ADDENDUM NO. 5

14-AUG-24

PHASE III FACILITY CONVERSION AT NEW GLOUCESTER STATE FISH HATCHERY

BGS PROJECT NO.: 3289-312

SHEET
02D-102

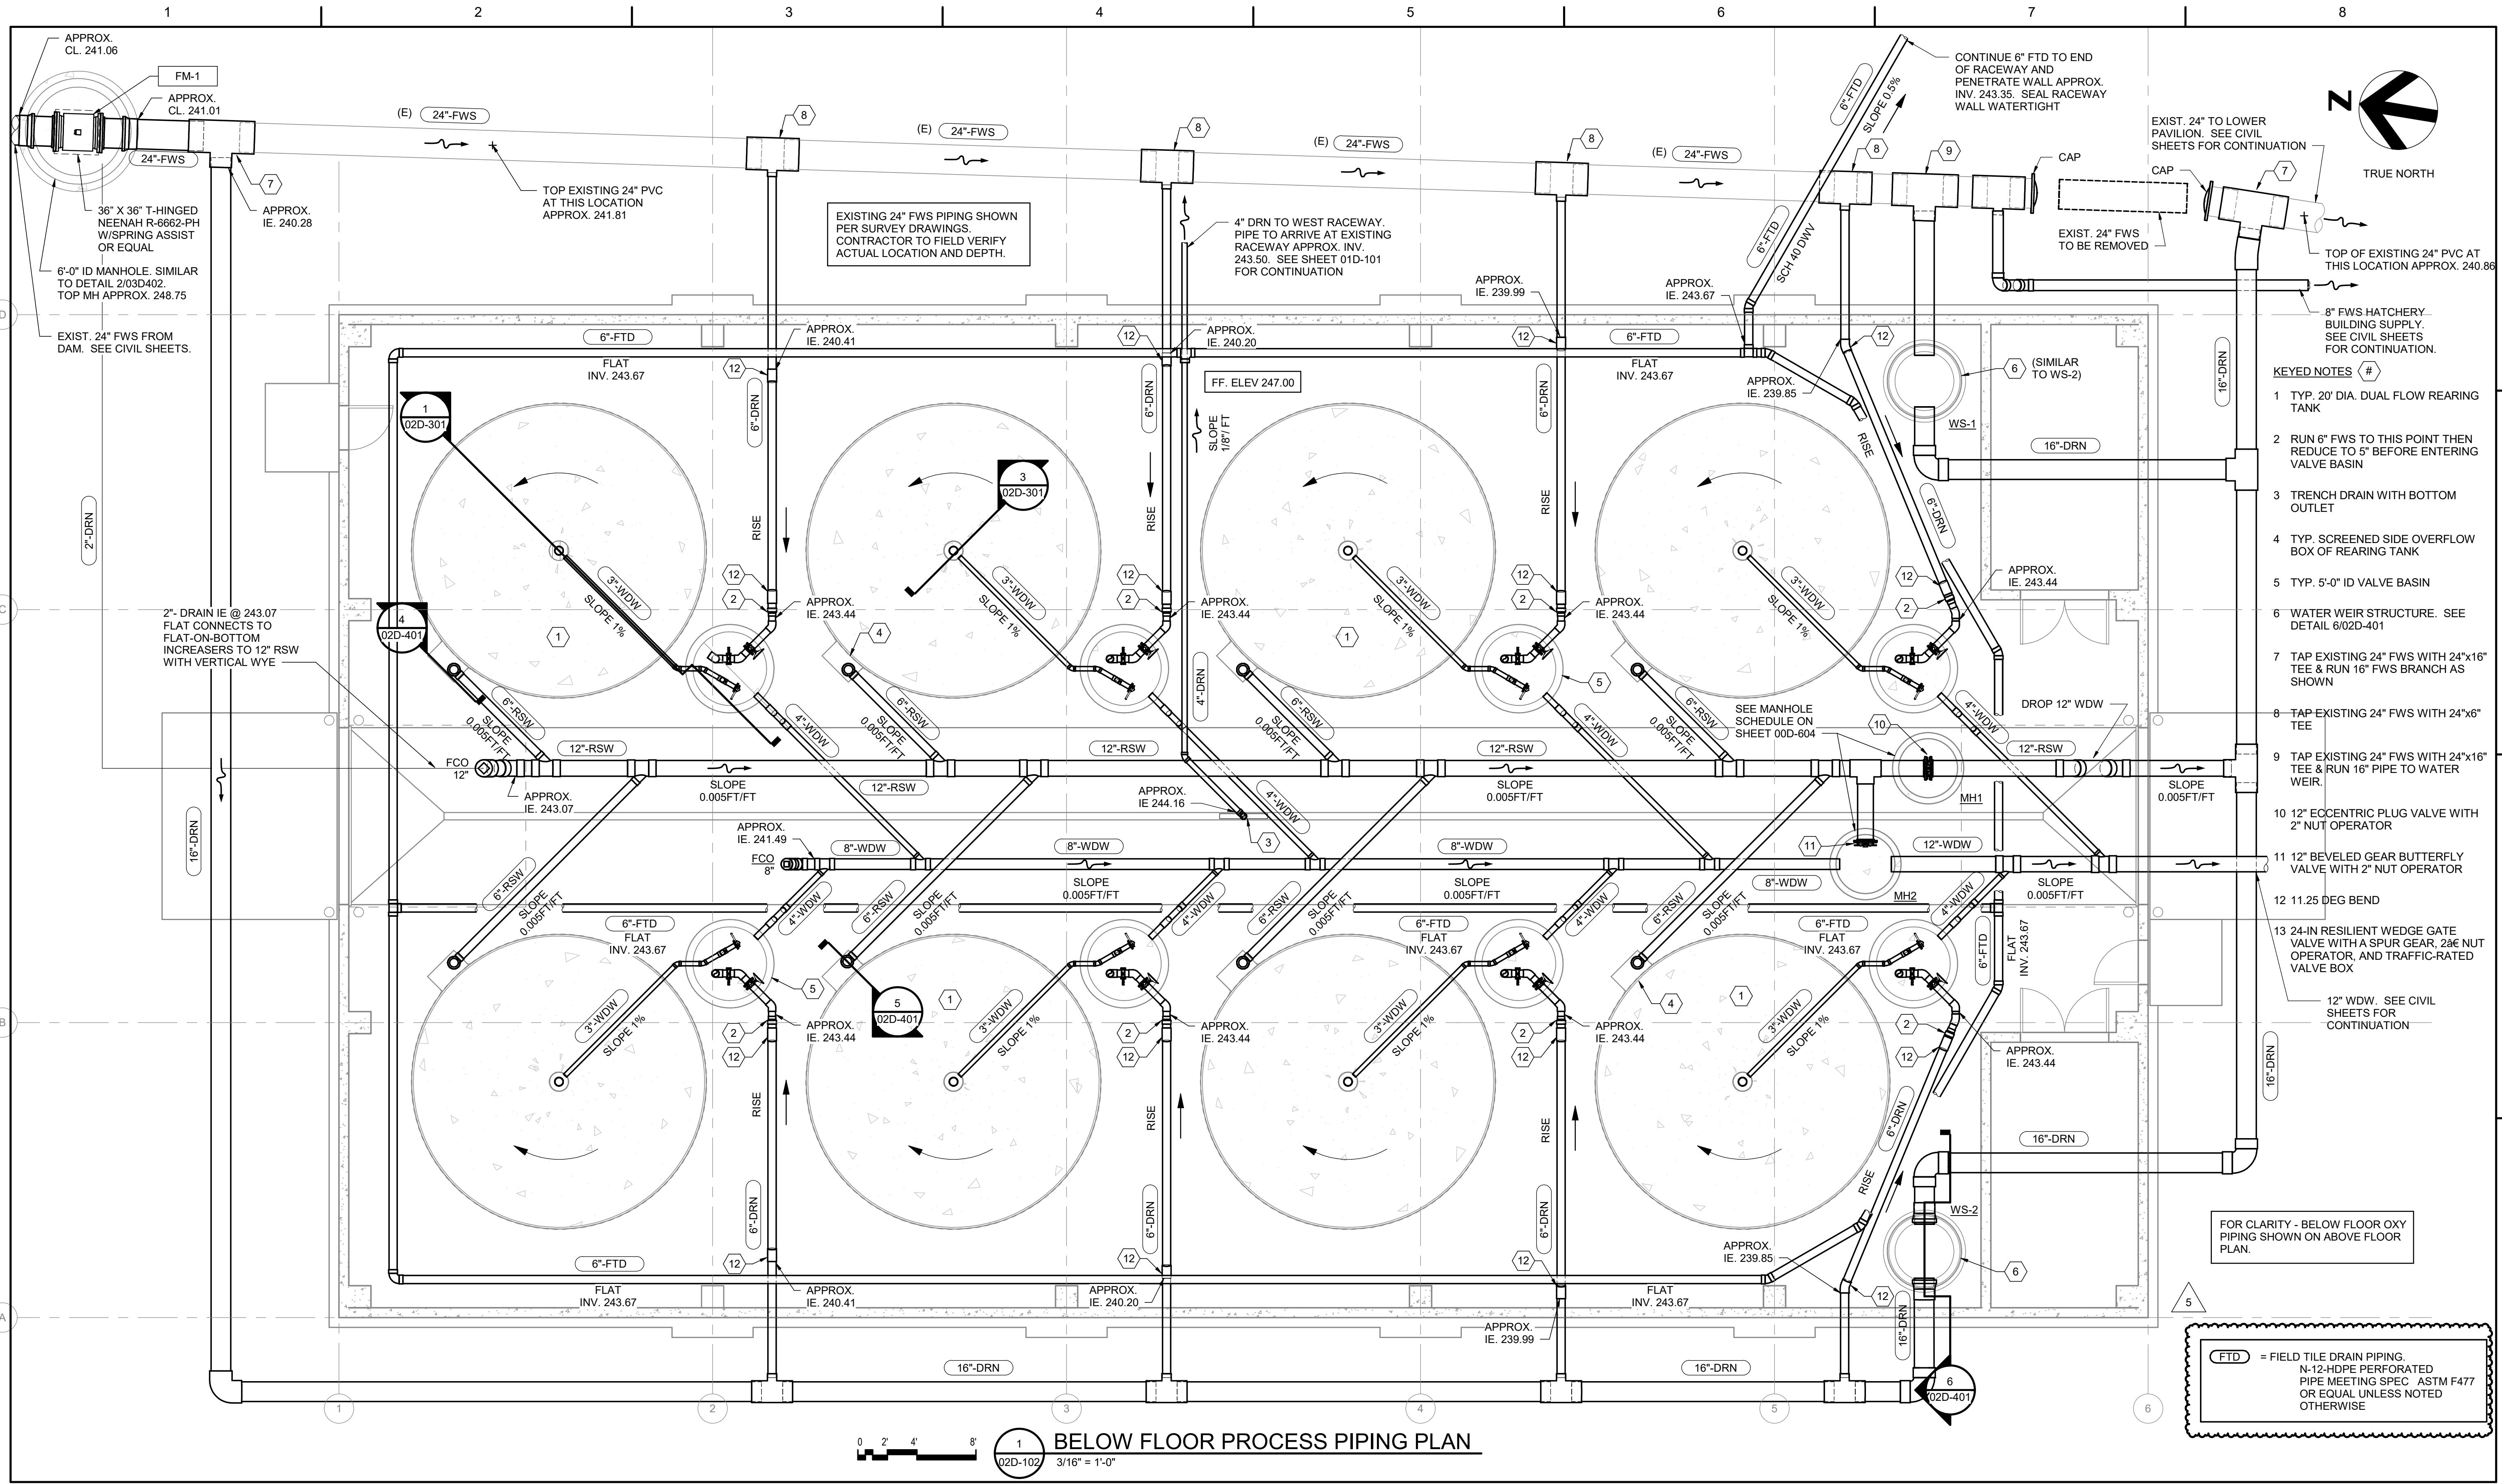
- a. **REPLACE SHEET:** Added 6”-FTD (FIELD TILE DRAIN)

FTD = FIELD TILE DRAIN PIPING.
 N-12-HDPE PERFORATED PIPE MEETING SPEC. ASTM F477 OR EQUAL UNLESS NOTED OTHERWISE

SHEET
02D-301

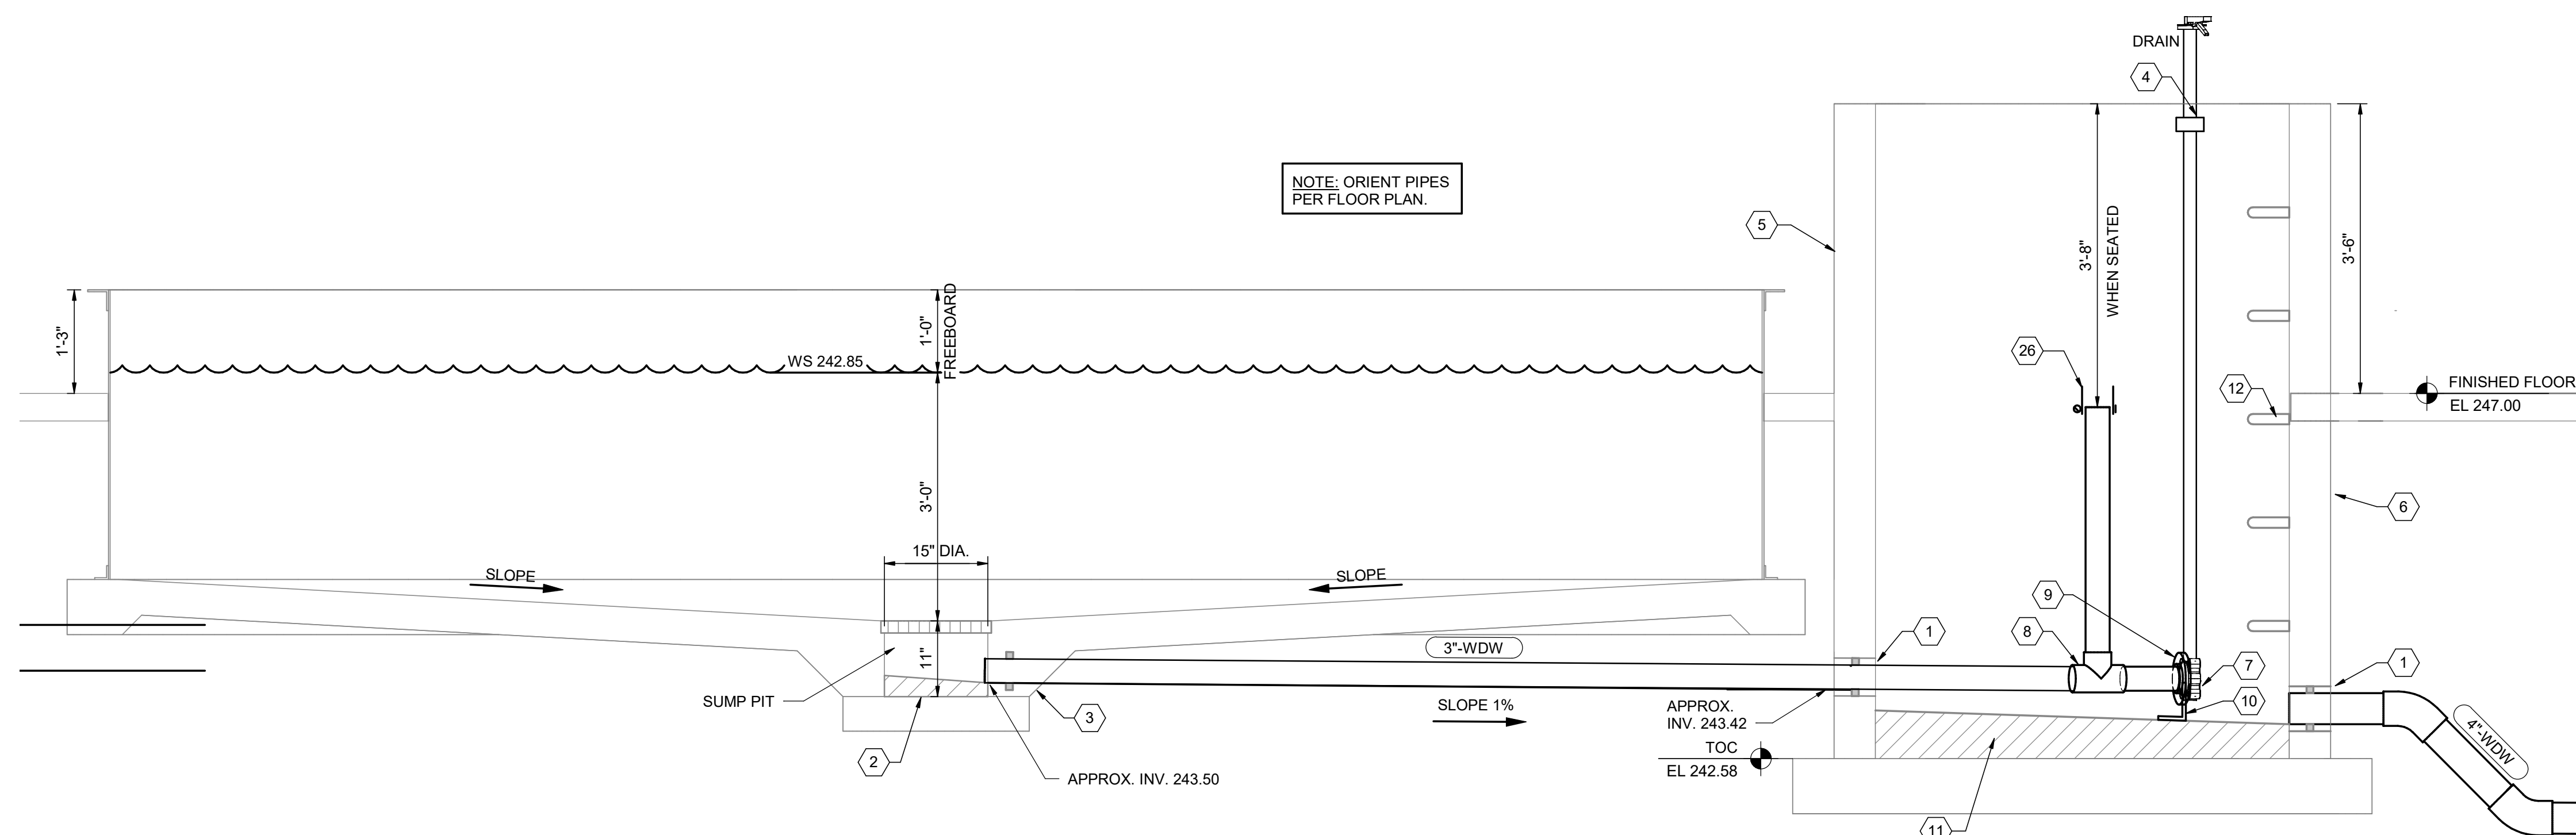
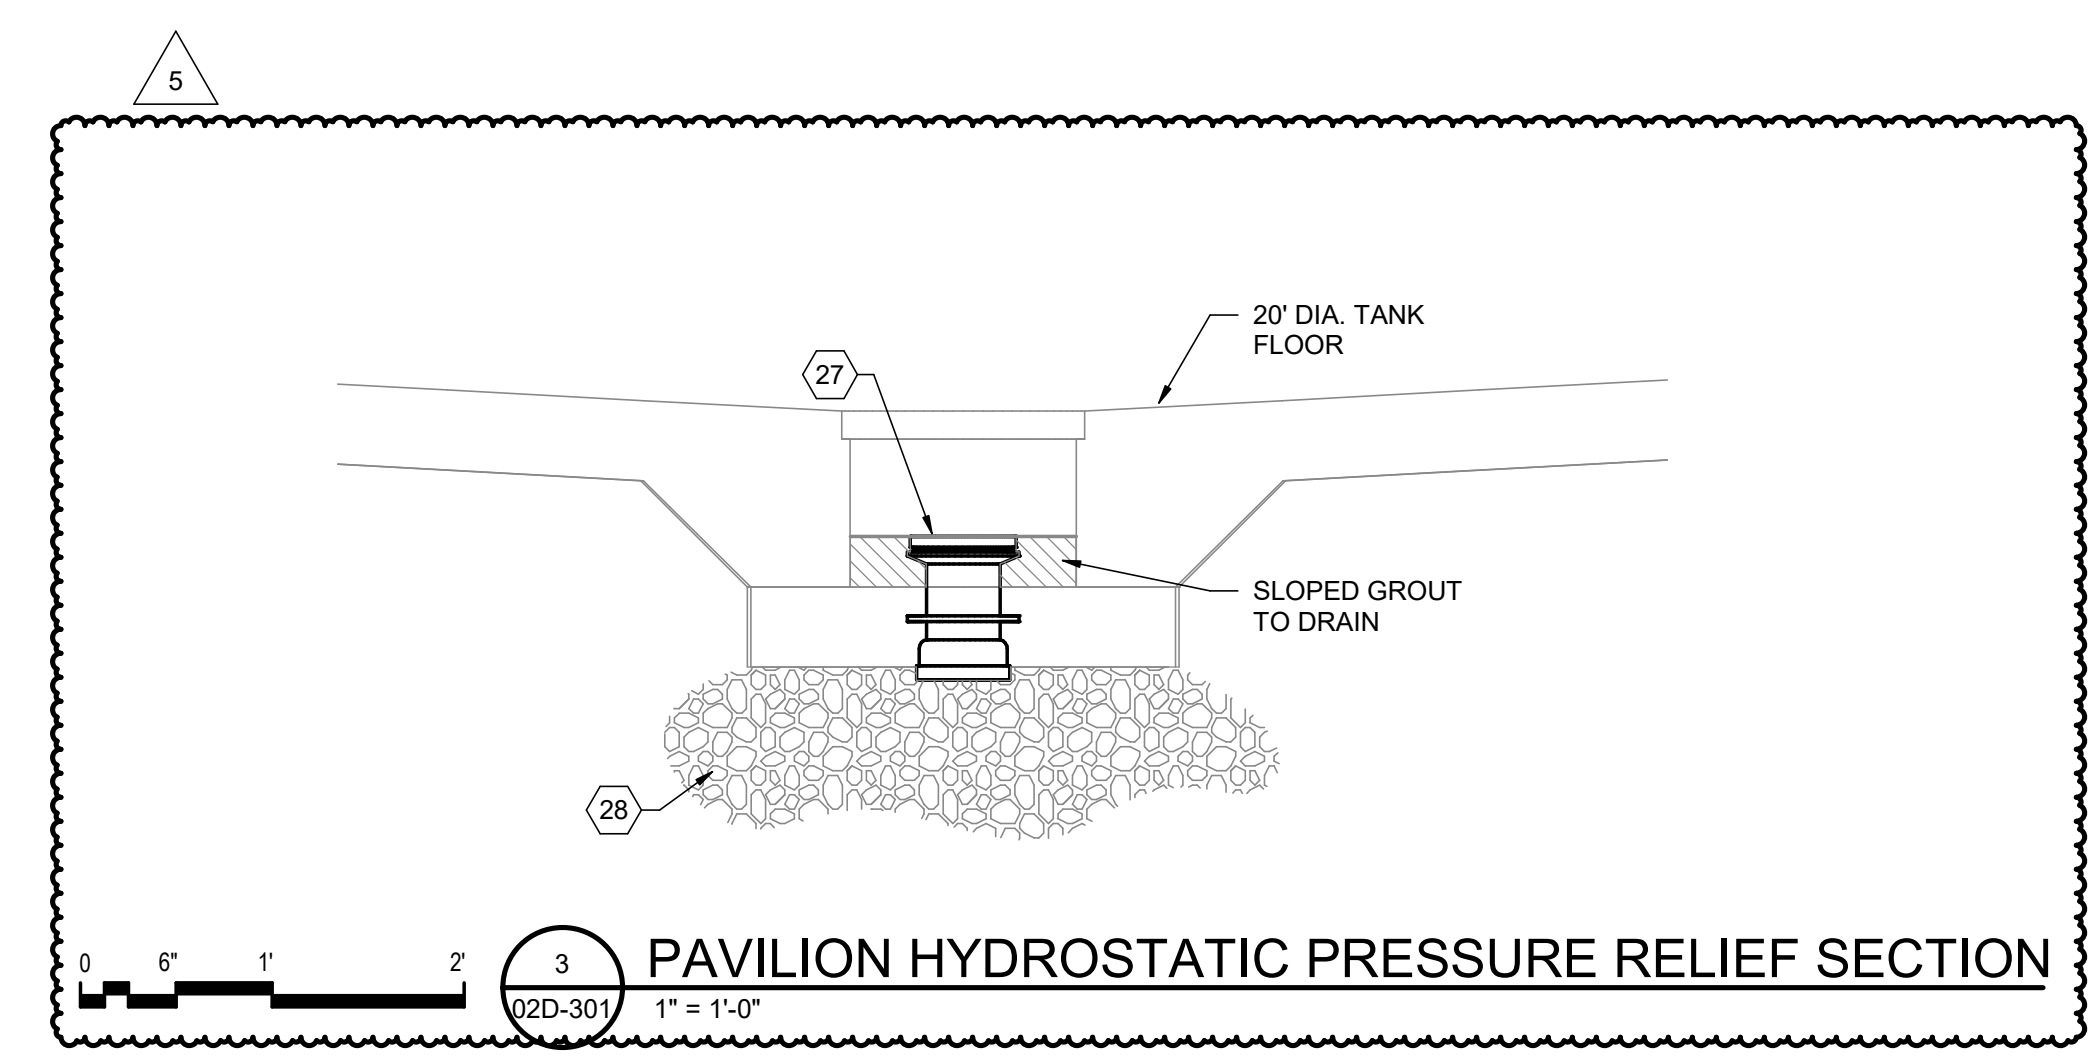
- a. **CHANGE: DETAIL 3**

0 6" 1" 2" **3 PAVILION HYDROSTATIC PRESSURE RELIEF SECTION**
02D-301 1" = 1'-0"

- ELASTOMERIC COUPLING
 - 4" FLOOR MOUNTED HYDROSTATIC PRESSURE RELIEF VALVE EQUAL TO PENN-TROY A2550RSN/4
 - MINIMUM 2'-6"x2'-6"x2'-6" CLEAN CRUSHED STONE WRAPPED IN GEOTEXTILE FABRIC CENTERED ON PRESSURE RELIEF VALVE PIPE
